**Planning Department  
Transportation Development Services**

**Re: Commercial & Apartment Building – Phase I  
4419 4<sup>th</sup> St., NW  
Traffic Circulation Layout  
Engineer's/Architect's Stamp dated 10-15-15 (G14-D066)**

Based upon the information provided in your submittal received 10-15-15, the above referenced plan cannot be approved for Building Permit until the following comments are addressed:

DRAWING TITLE  
**Traffic Circulation Layout**

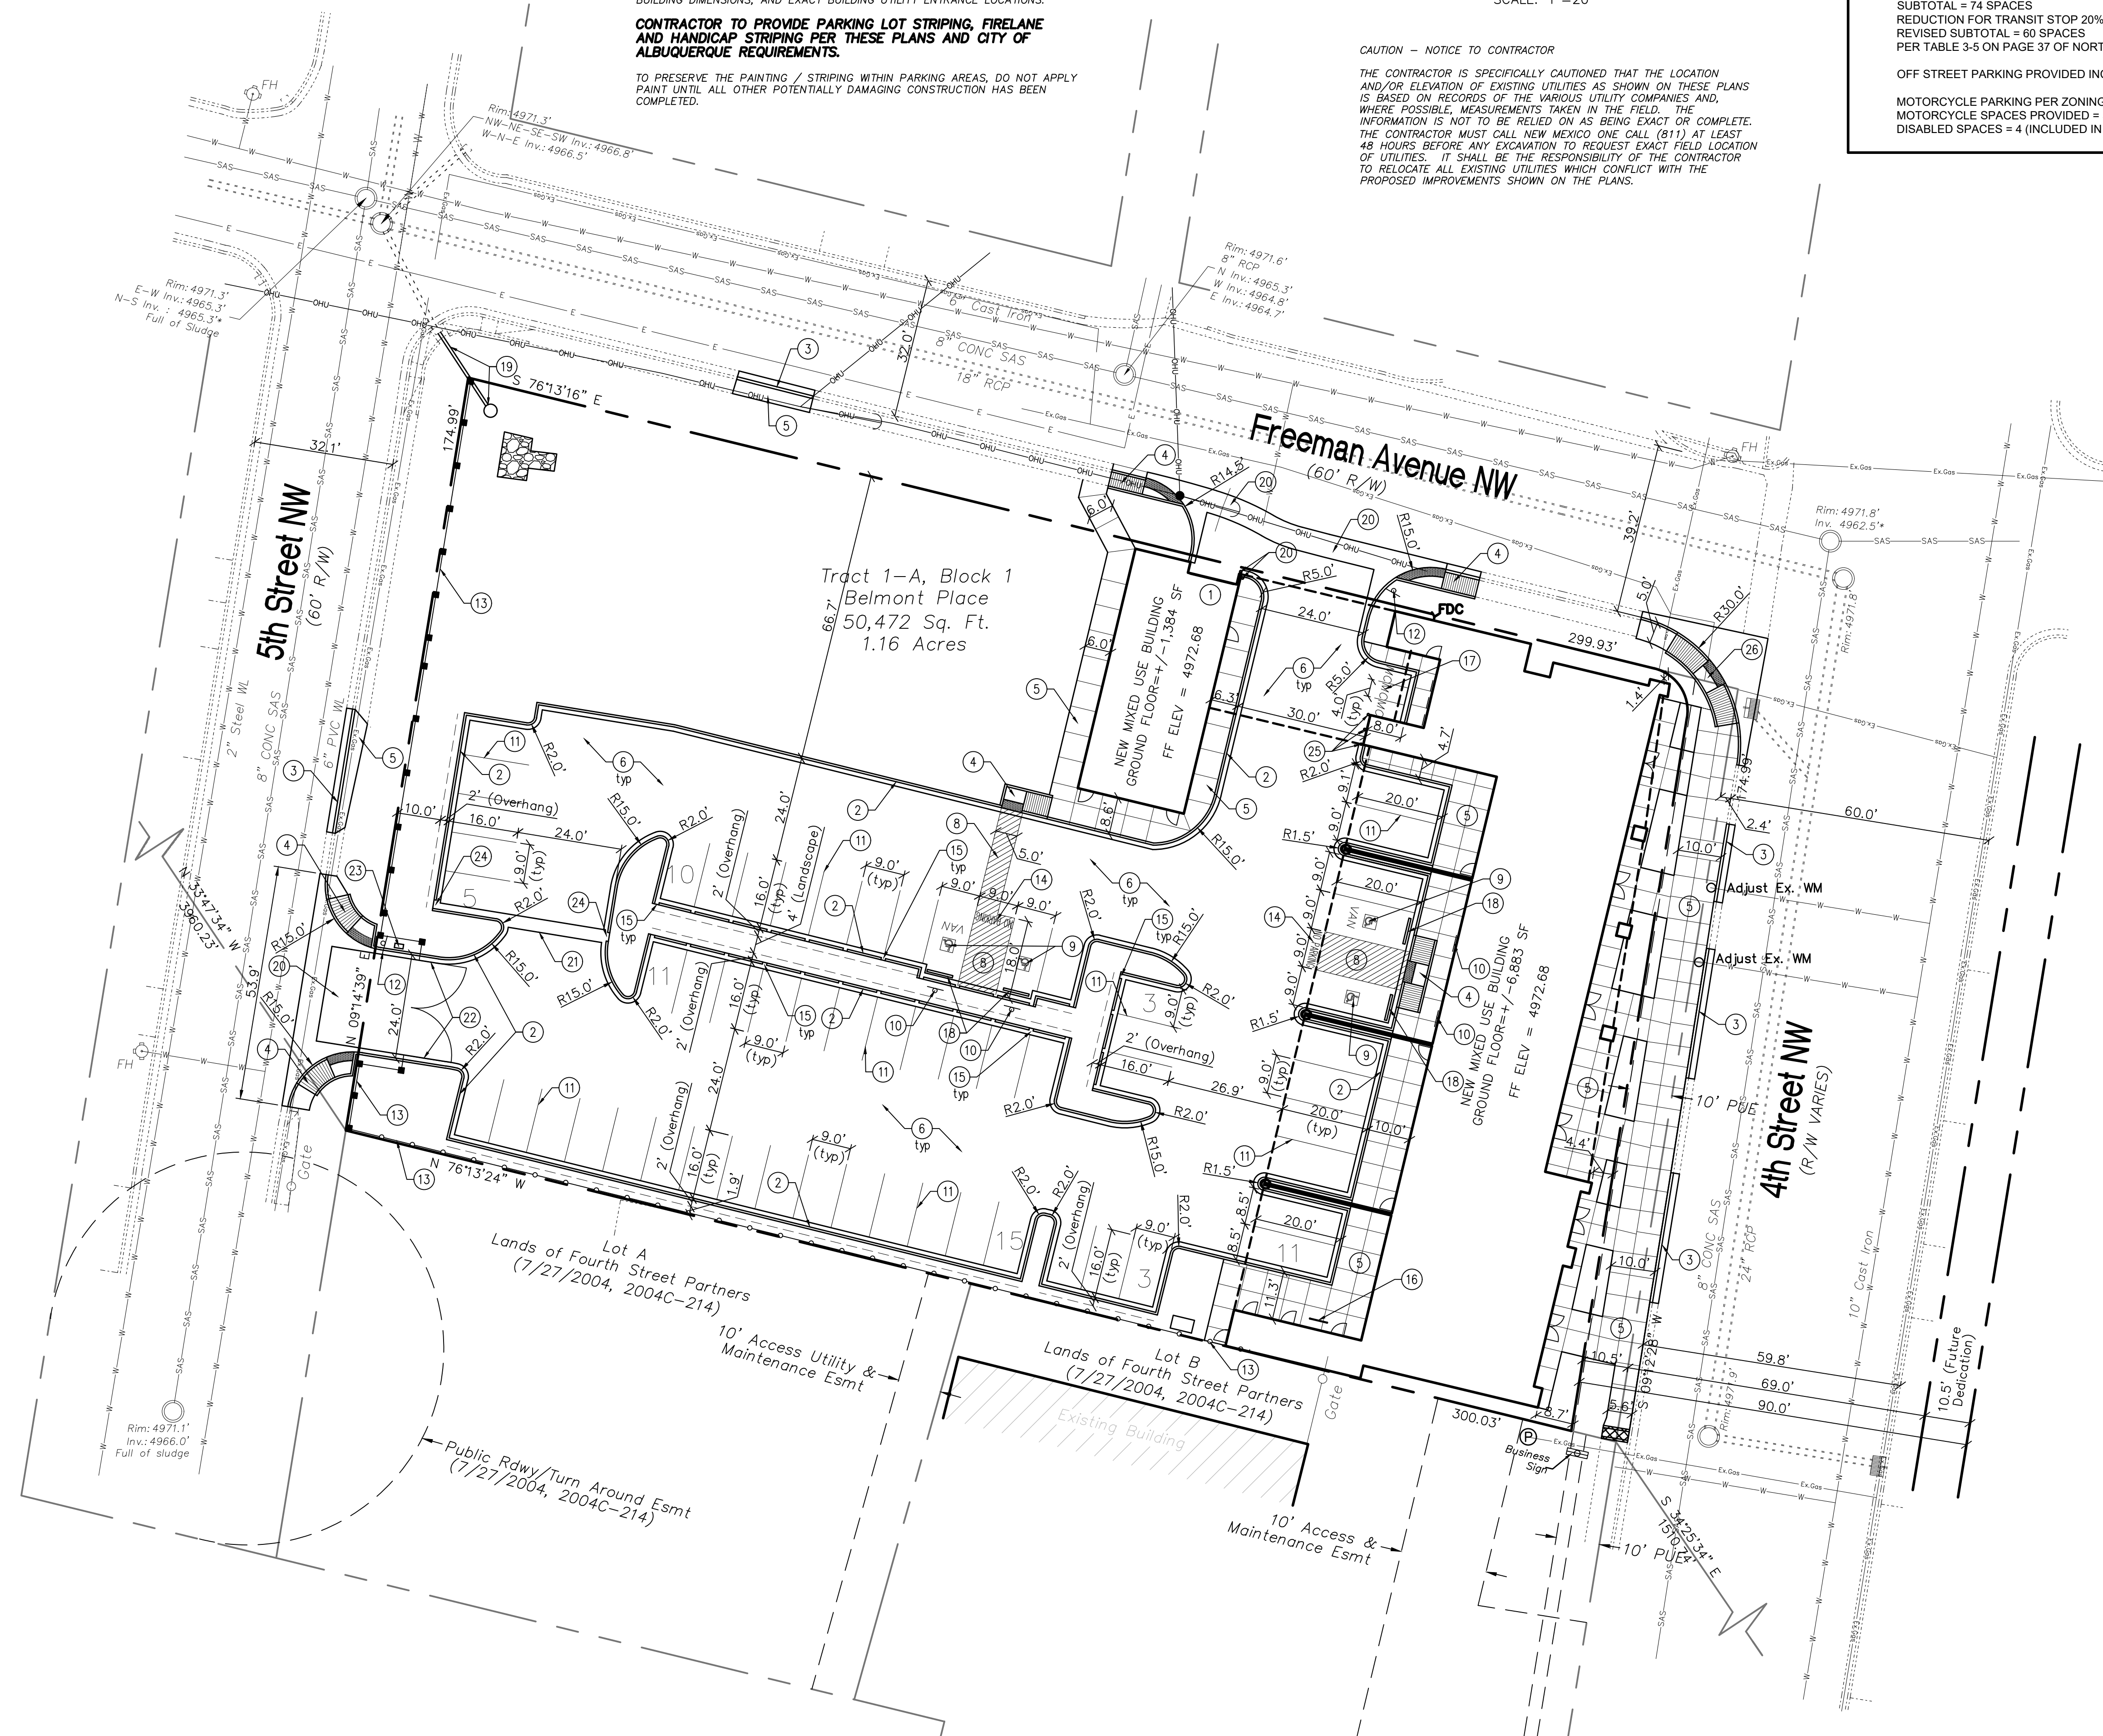
1. Per the DPM, a 6 ft. wide ADA accessible pedestrian pathway is required from the public sidewalk to the building entrances. Clearly detail ADA pathway from both Freeman Ave. and 4<sup>th</sup> St. to proposed building on the east end of the proposed project fronting 4<sup>th</sup> St.

2. Per the DPM, a 6 ft. wide ADA accessible pedestrian pathway is required from the HC parking stall access aisles to the building entrances. Please detail ADA accessible pedestrian pathway from parking island ADA spaces to proposed mixed used building at the east end of the project site. Clearly detail the pathway from the ADA pathway to the proposed mixed used building on the east end of the project. The ADA pathway detailed on the drawing is 5 ft. wide and only provides a pathway to proposed mixed use building to the north.

3. Design delivery vehicle route needs to be shown.
4. Service vehicle and/or refuse vehicle maneuvering must be contained on-site; provide a copy of refuse approval. Please detail location and refuse container.

5. Please provide a sight distance exhibit (see the *Development Process Manual, Chapter 23, Section 3, Part D.5 Intersection Sight Distance*). Please show this detail for drive pad entrances/exits on 5<sup>th</sup> St. and Freeman Ave.

6. Please add the following note to the clear sight triangle: "Landscaping and signage will not interfere with clear sight requirements. Therefore, signs, walls, trees, and shrubbery between 3 and 8 feet tall (as measured from the gutter pan) will not be acceptable in this area."
7. Unused curb cuts must be replaced with sidewalk and curb & gutter. A build note must be provided referring to the appropriate City Standard drawing.
8. Please include two copies of the traffic circulation layout at the next submittal.
